**36 Redington Road, London,
NW3 7RT**

**Basement Impact Assessment
Audit**

London Borough of Camden

Project Number: 12066-41
Revision: D2

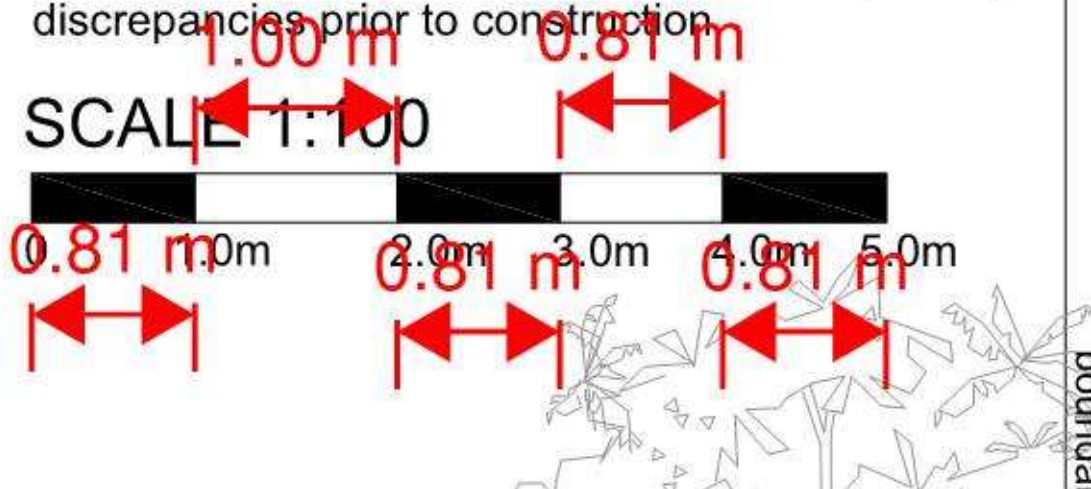
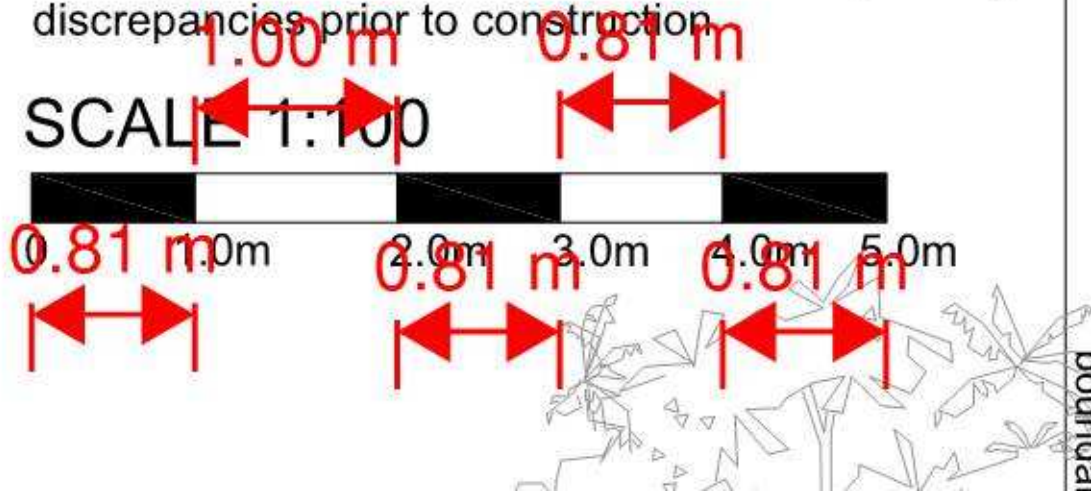
Please provide a set of drawings with an accurate scale bar.

STAGE -2a Installation of Raking Props

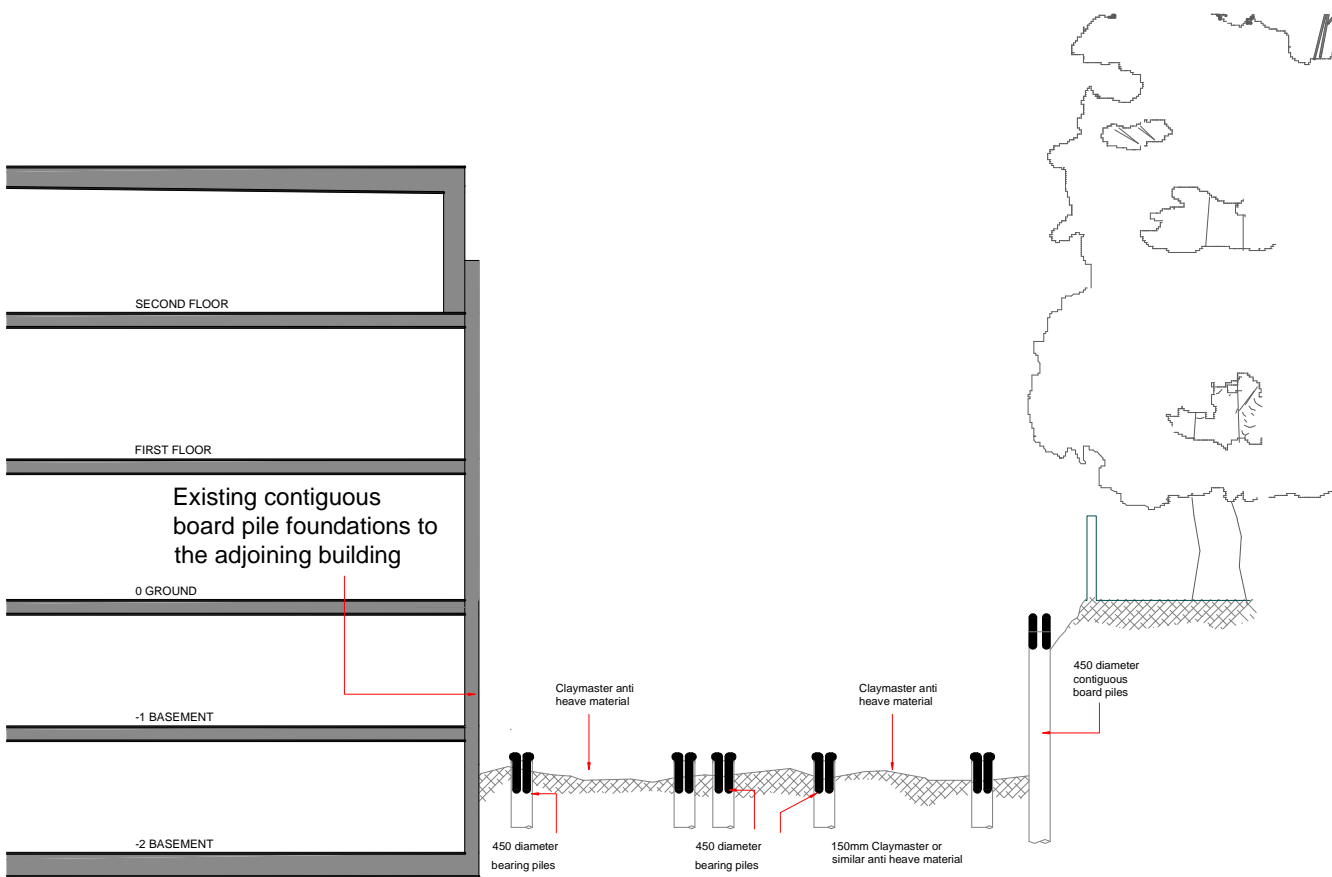
- 4.10. The revised Zussman Bear SER makes reference to propping in the temporary case to control ground movements and restrict damage. However, there is confusion in the document over raking and flying shores. Additionally, temporary props are referred to only in Stage 2 of the construction sequence, with the remainder of the stages continuing to refer to cantilever walls.

Figure EL2

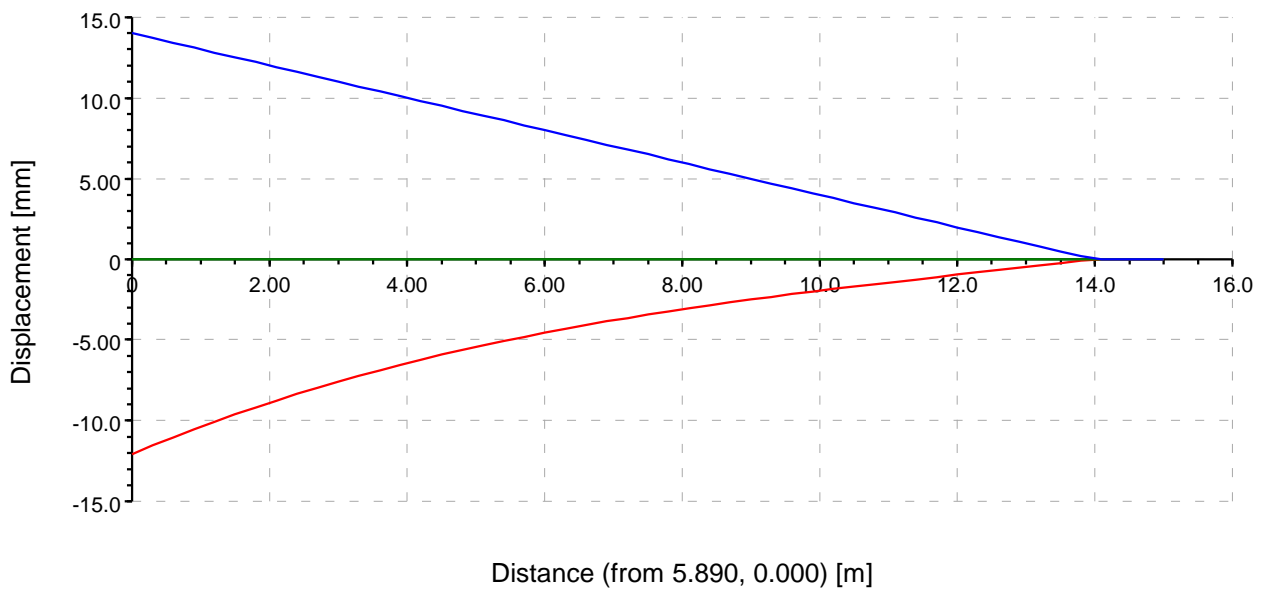
In the case of the adjacent highway (Figure EL2) horizontal movements at the boundary of the site i.e. 1m from the wall are predicted to be 13mm reducing to zero 14m from the wall (13m from the
